MIDLAND ENERGY CENTER
MIDLAND DOCKET NOS. 50-329, 50-330
AUXILIARY BUILDING MOVEMENT GUIDELINE FOR
TEMPORARY UNDERPINNING
FILE 0485.16 SERIAL CSC-7809

GUIDELINES FOR BUILDING MOVEMENTS DURING
TEMPORARY UNDERPINNING

APPLICANT: Consumers Power Company
FACILITY: Midland Plant, Units 1 and 2
SUBJECT: SUMMARY OF FEBRUARY 2-5, 1982 MEETING AND AUDIT ON AUXILIARY
BUILDING UNDERPINNING

FIGURE 2

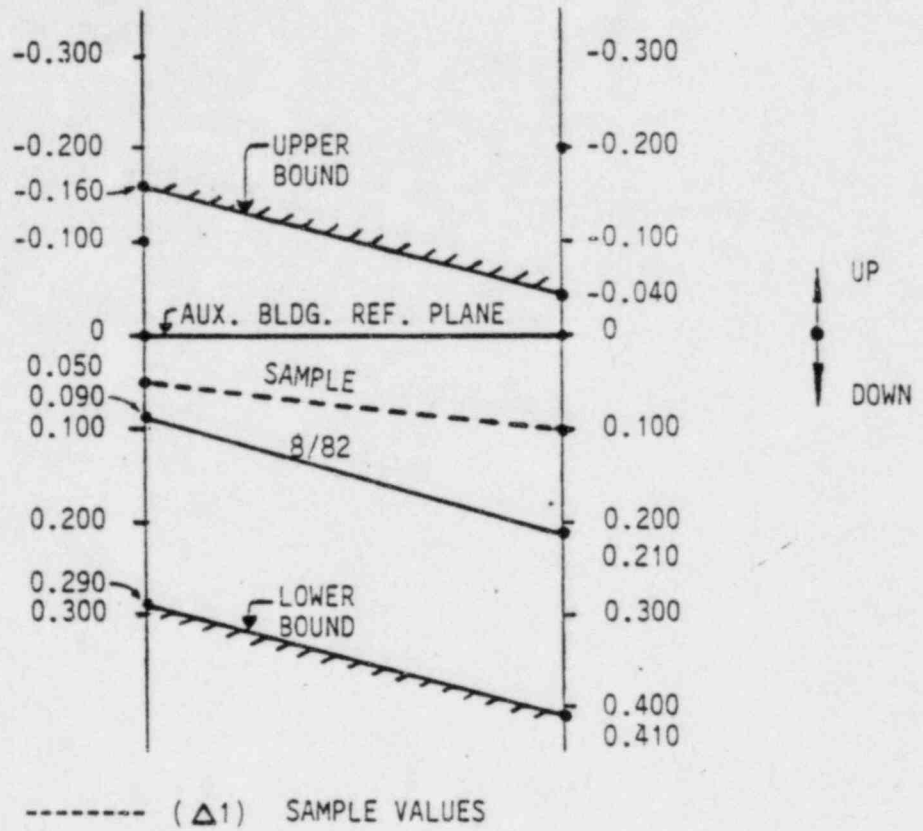
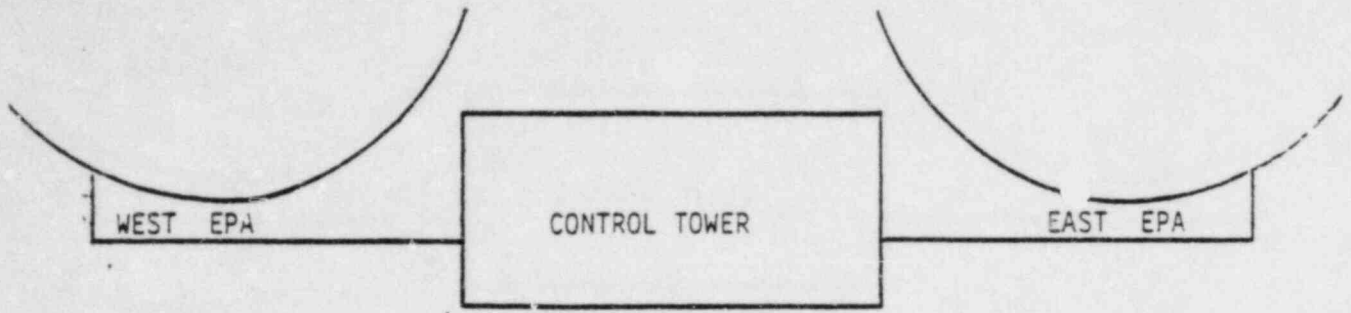
- (a) EAST EPA RELATIVE MOVEMENT LIMITS (FIGURE 2) -
The lower bound of the east EPA relative movement will be 370 mils in 90', the length of the EPA. The upper bound will be 0 mils in 90'. The relative movement as of August, 1982 was 320 mils in 90'.

- (b) WEST EPA RELATIVE MOVEMENT LIMITS (FIGURE 2) -
The lower bound of the west EPA relative movement will be 100 mils in 90' and the upper bound will be -100 mils in 90'. The relative movement as of August, 1982 was 60 mils in 90'.

FIGURE 3

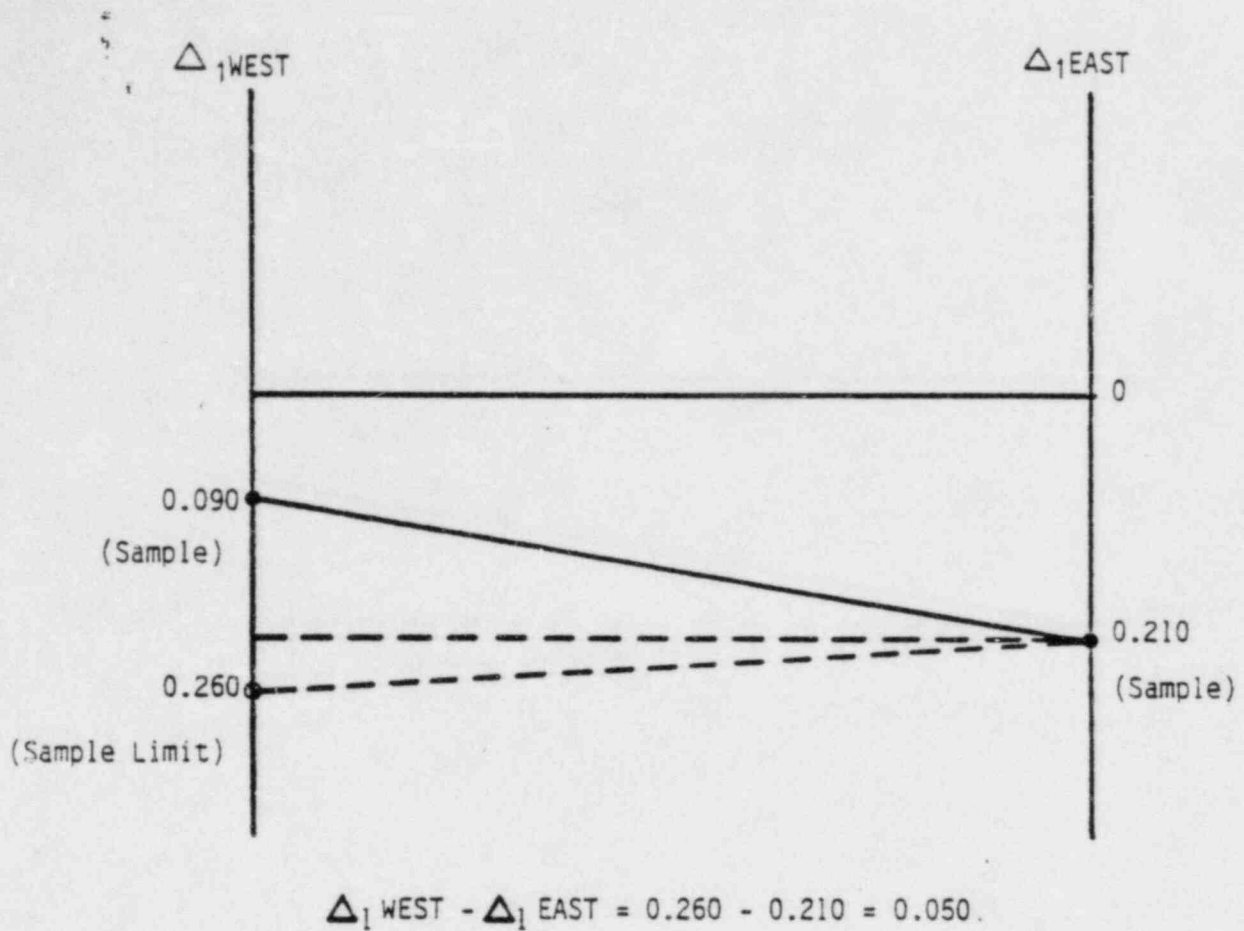
- (c) CONTROL TOWER RELATIVE MOVEMENT LIMITS (FIGURE 3 and Figure 5) -
Limit the downward relative movement (Δ_1) of the Control Tower to be less than 200 mils with respect to the August, 1982 values. Also, limit the upward relative movement (Δ_1) of the Control Tower to be less than 250 mils with respect to the August, 1982 values.

FIGURE 4

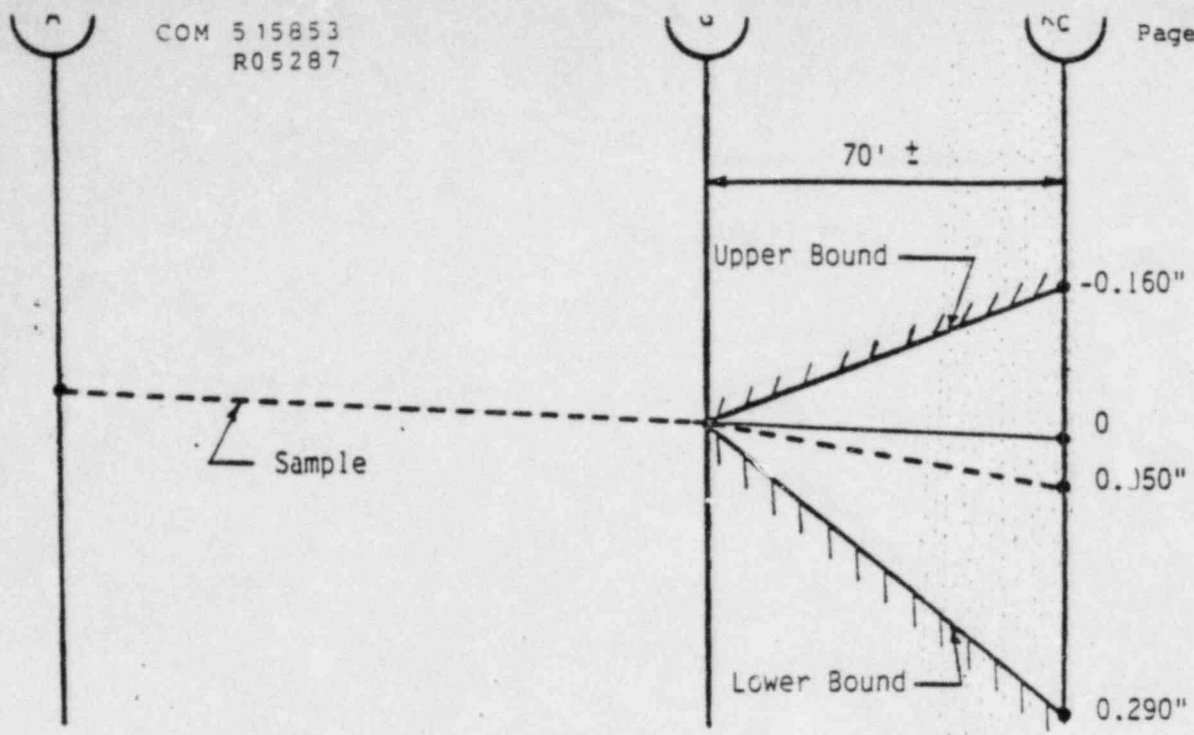
- (d) CONTROL TOWER ROTATIONAL MOVEMENT LIMITS (FIGURE 4) -
Limit the rotation of Control Tower to be within 50 mils in 100' and -170 mils in 100', the length of the Control Tower. The rotation as of August, 1982 is -120 mils in 100'.

FIGURE 7-2A

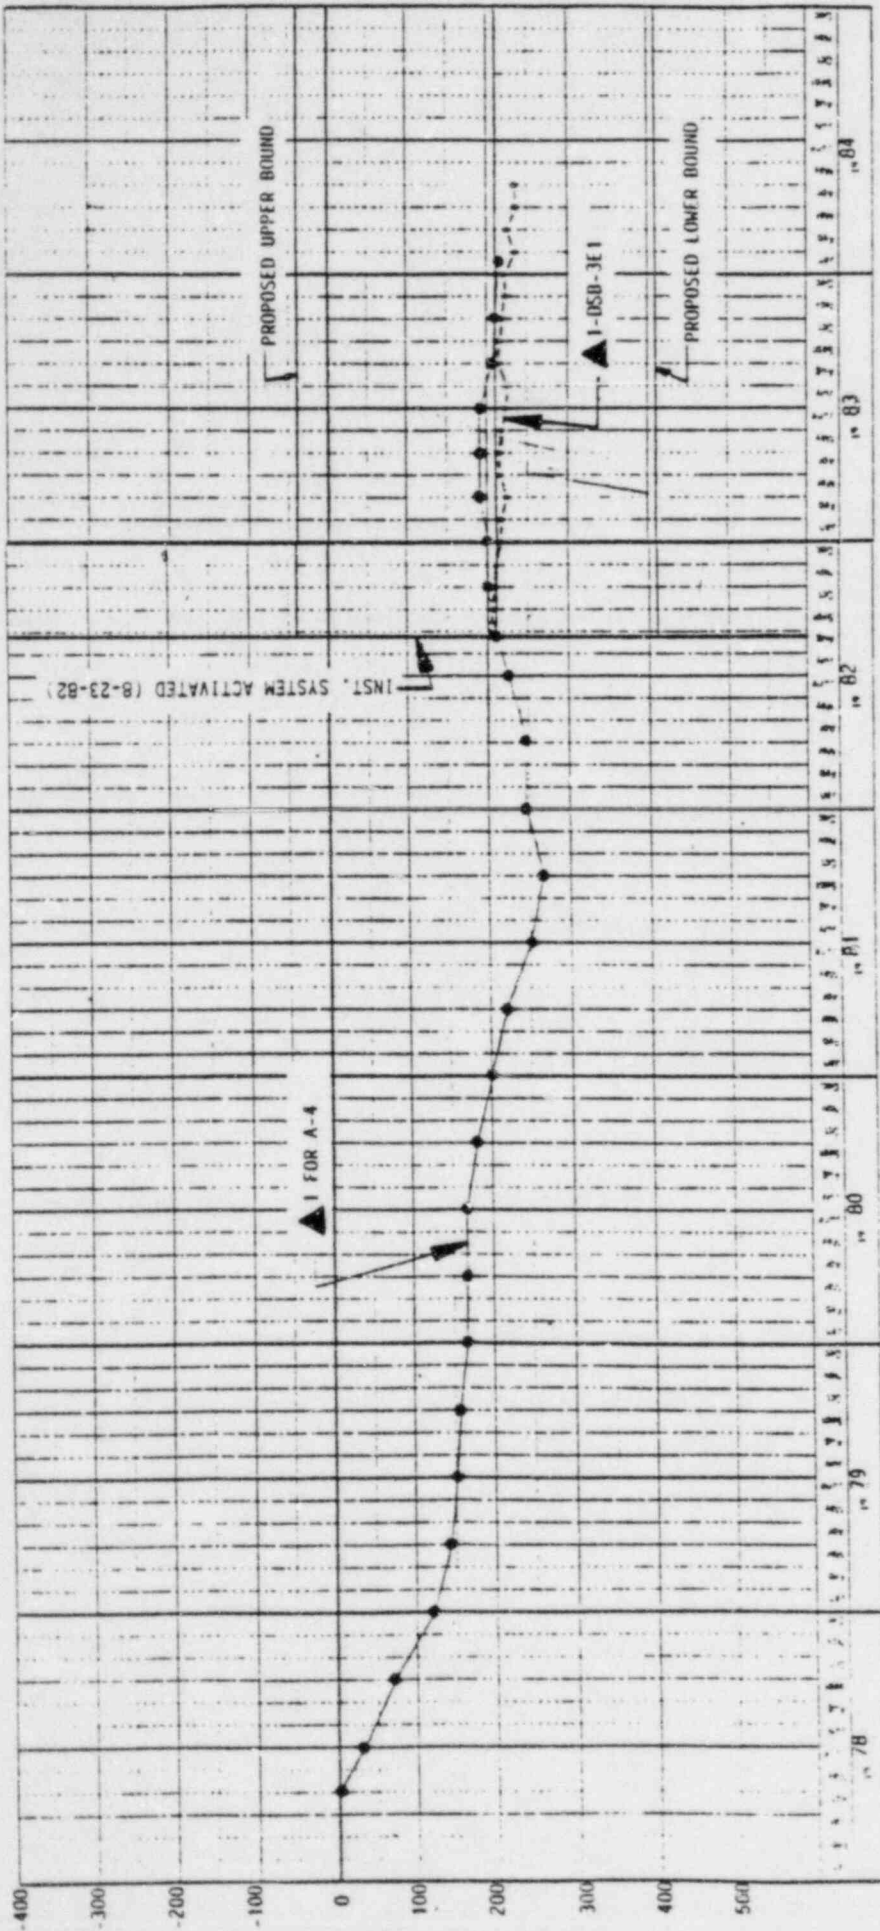
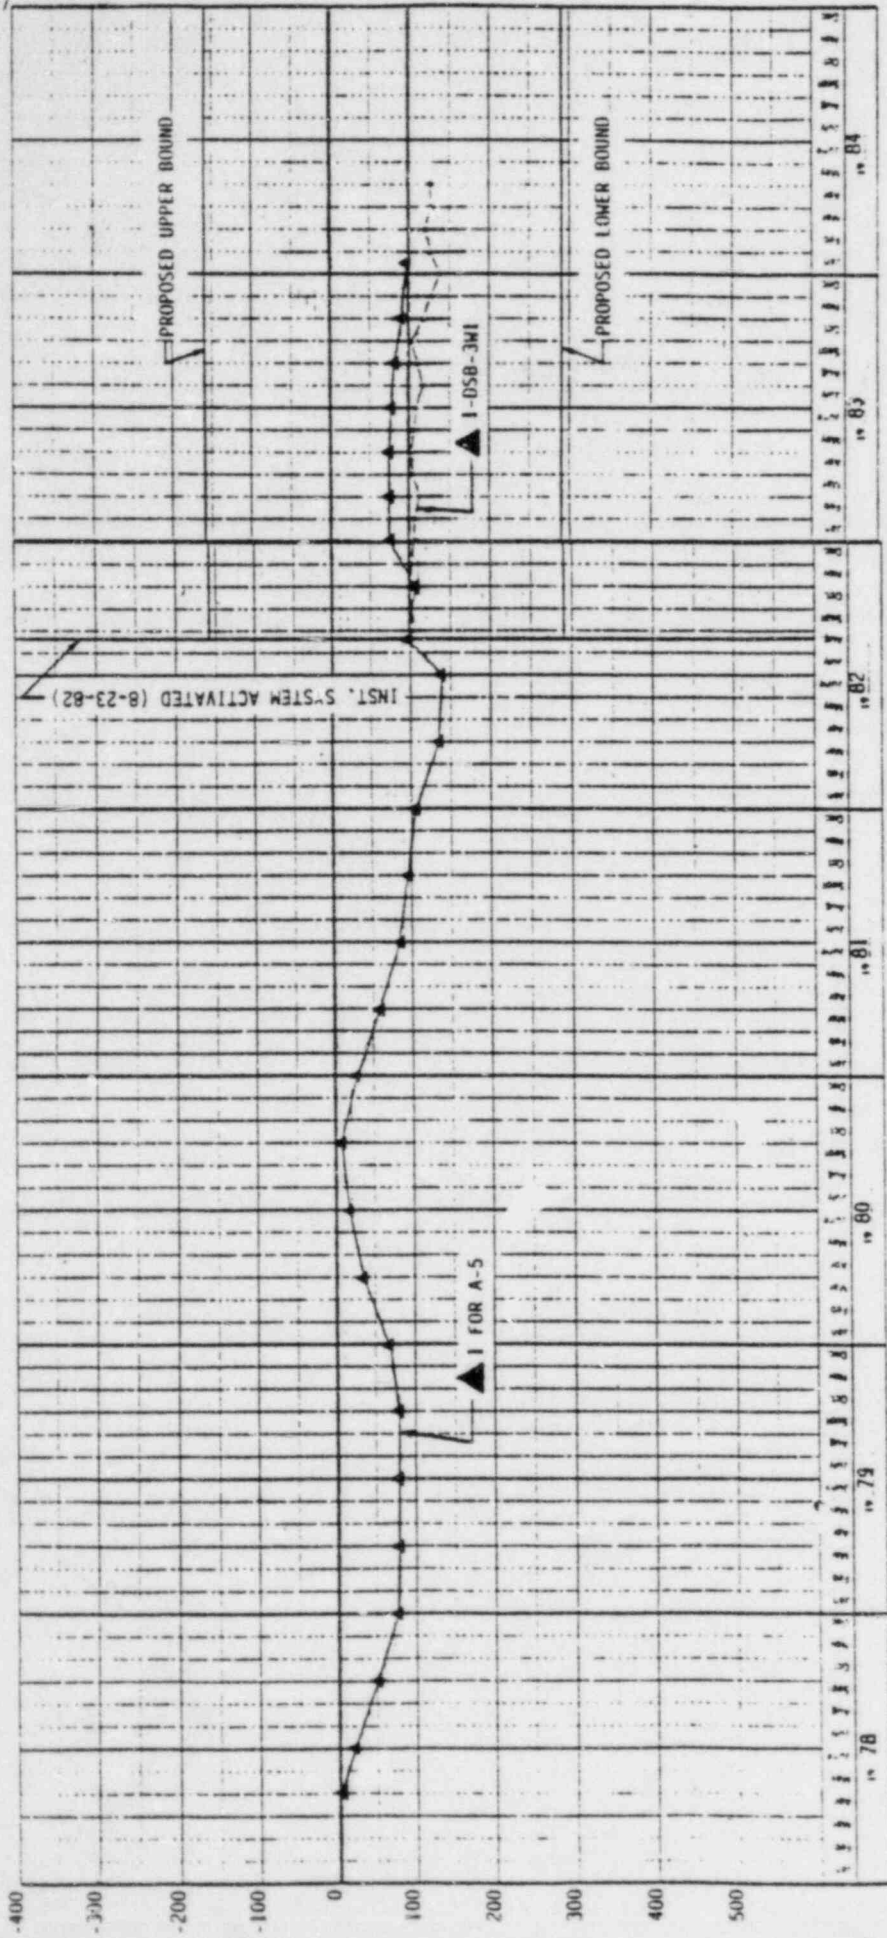
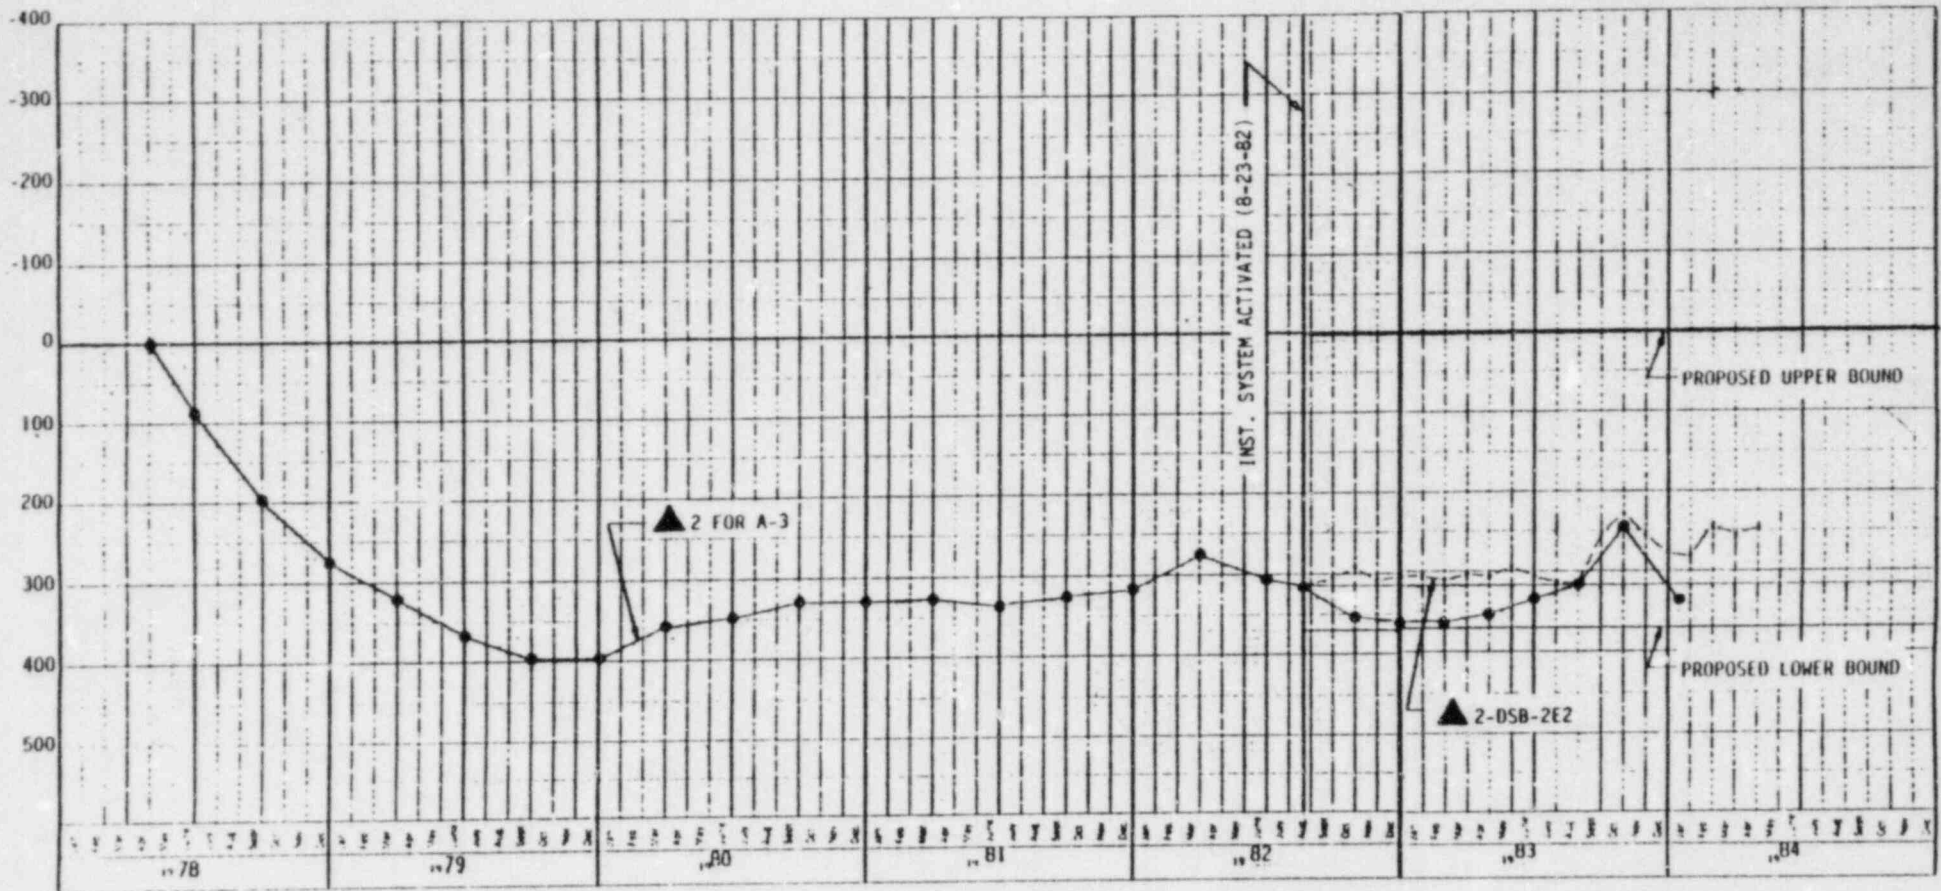
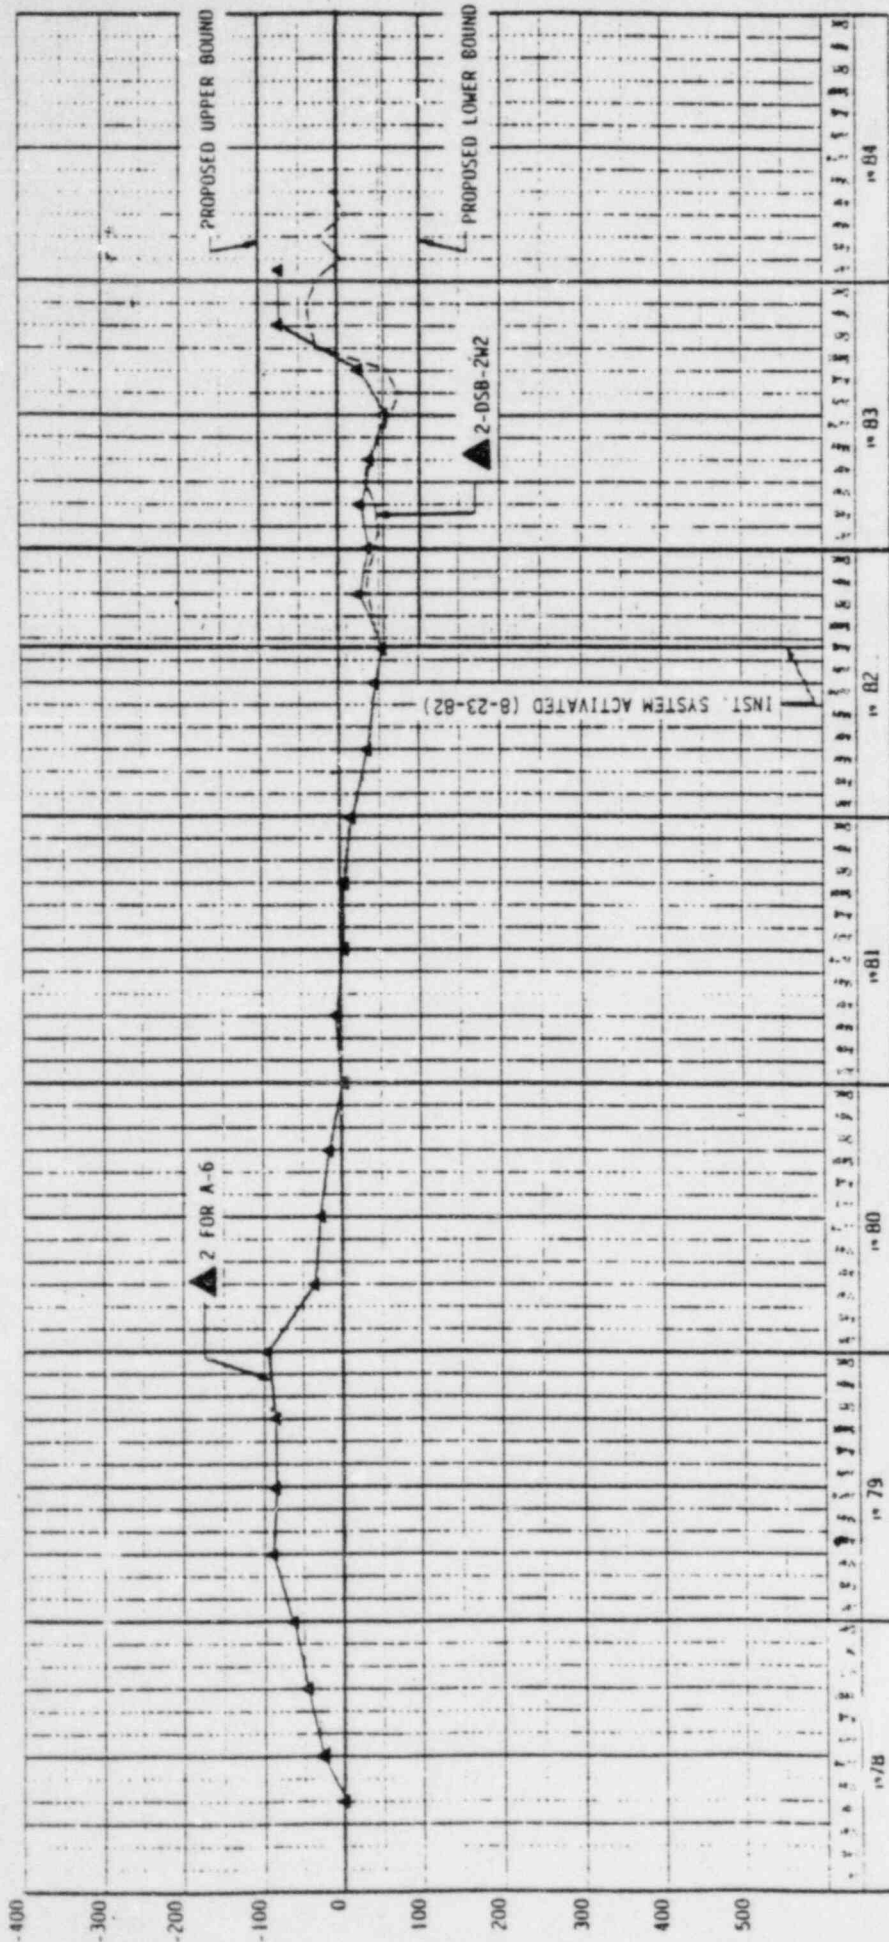
Figures 7-2 (A&B) and 7-3 (A&B), provided during the April 4-6, 1984 meeting, were based on a straight line representation of the survey data and have been revised based on smooth curve representations of the survey data. The guidelines utilize the smooth curve representations.
